City of Seattle  
Hearing Examiner Exhibit

FILE # CF-314356

**From:** Esther Bartfeld <ebartfeld@comcast.net>  
**Sent:** Friday, April 27, 2018 1:33 PM  
**To:** Examiner, Hearing  
**Subject:** Comments for CF314356, proposed contract rezone of 7009 Greenwood (for Hearing 4.30.18)  
**Attachments:** 7009, comments for revised application 3.18.18.pdf

King County Parcel Viewer showing 4 separate lots, 4 separate recording numbers for lots in 7009 project

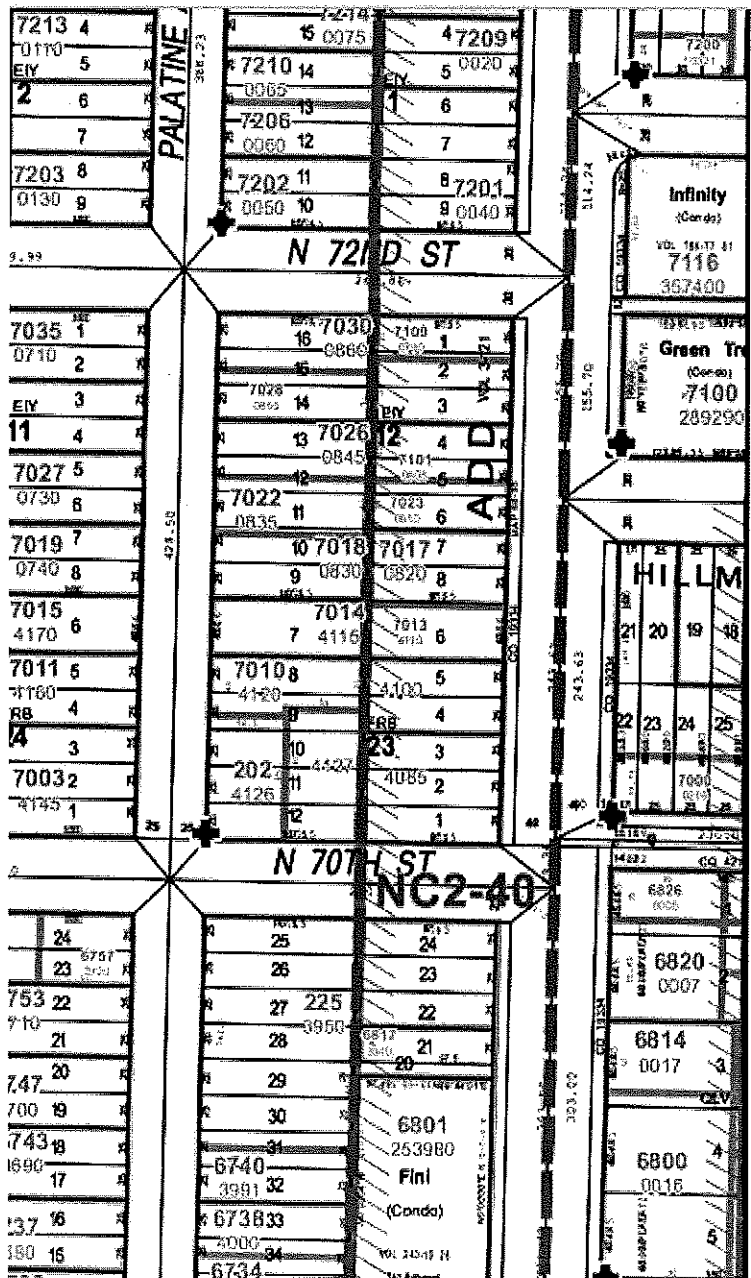
The parcel map attached to these comments shows the north/ south zoning line that divides the block between Greenwood and Palatine between 70<sup>th</sup> and 72<sup>nd</sup>. All parcels on Greenwood are zoned NC, all parcels on Palatine are zoned SF. The proposed building is built right on the property line for four stories, with a minimal setback at most (but not all) of the fifth floor. This placement violates the following Code provisions:

-shows zoning line running N/S at the rear property lines for several blocks in that area
